ADDENDUM NUMBER TWO

100% Construction Documents (Dated 11.04.22)

Date: **December 21, 2022**

Project: **Sandia Base Elementary School**

1 HVAC LEVEL 2 FLOOR PLAN - AREA C
 1/8" = 1'-0"

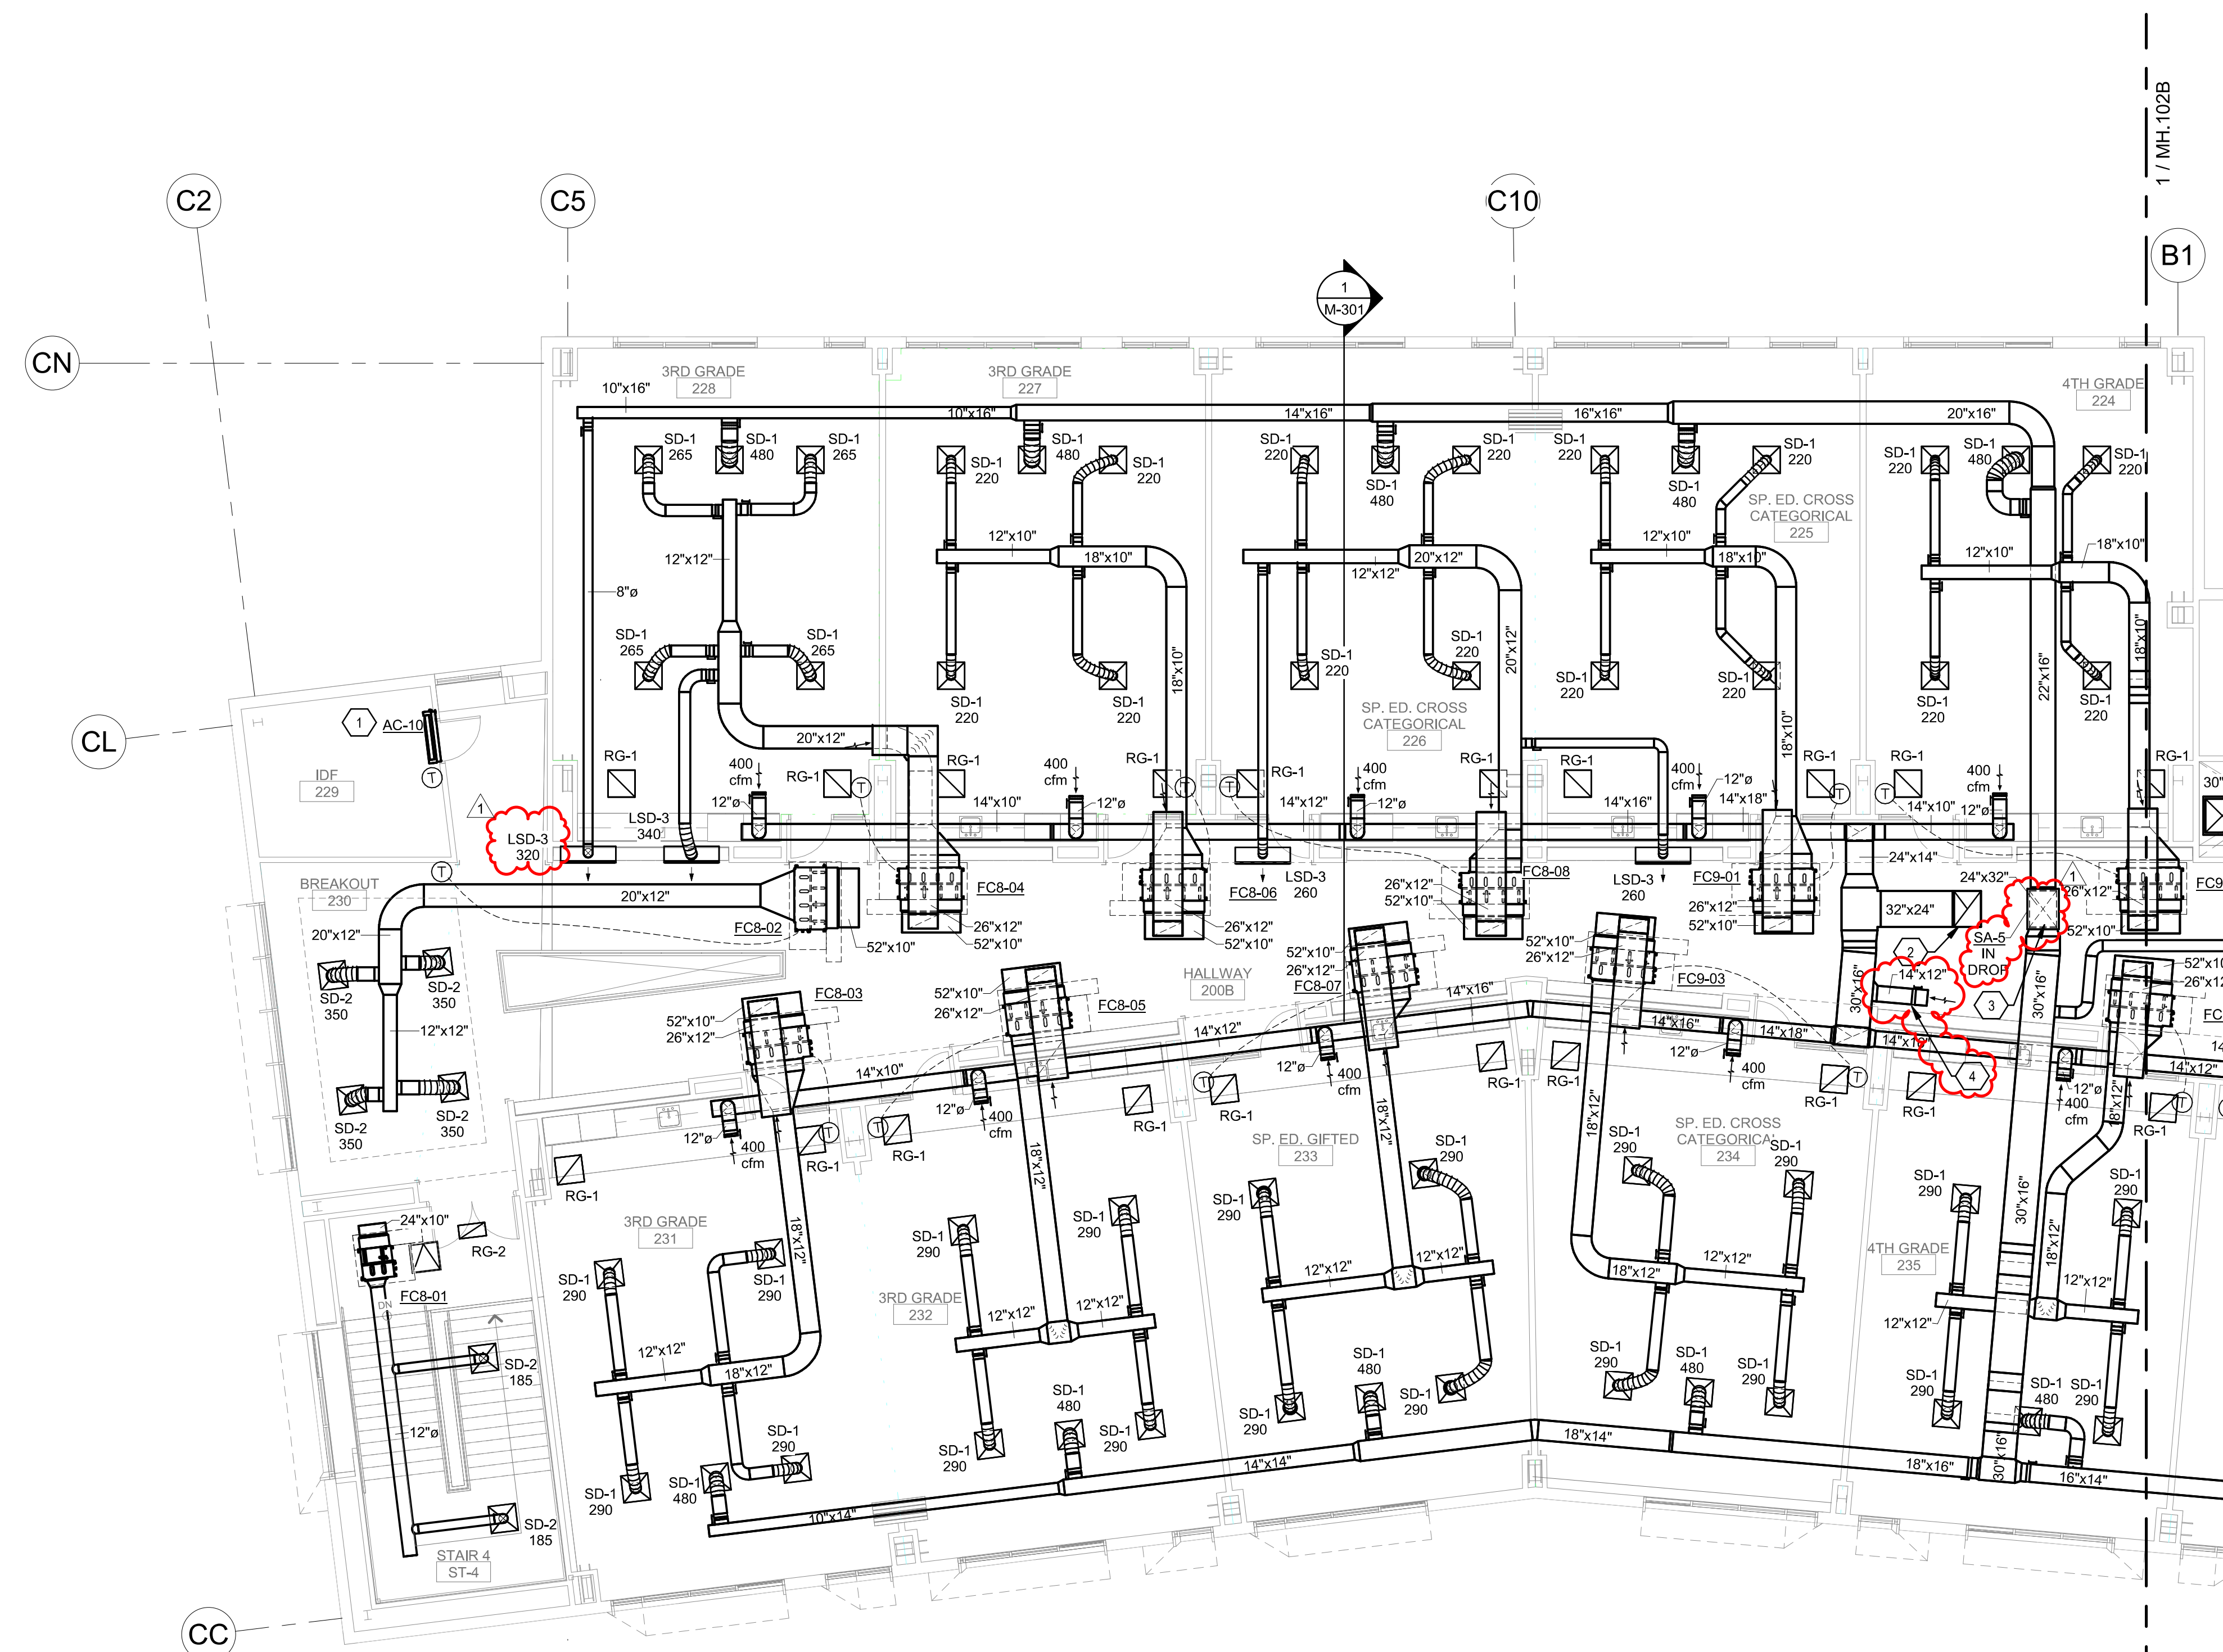
5. Sheet MH.102C – HVAC LEVEL 2 FLOOR PLAN – AREA C
 1. **ADD** sound attenuator, SA-5, to DOAS-5 supply duct drop.
 2. **MODIFY** cfm value in Hallway 200B.

3. **ADD** keyed note 4.
 4. **ADD** exhaust duct and balancing damper to Hallway 200B.
 6. Sheet M-502 – MECHANICAL DETAILS
 1. **ADD** Drum Punkah Louver Connection Detail, A4/M-502.
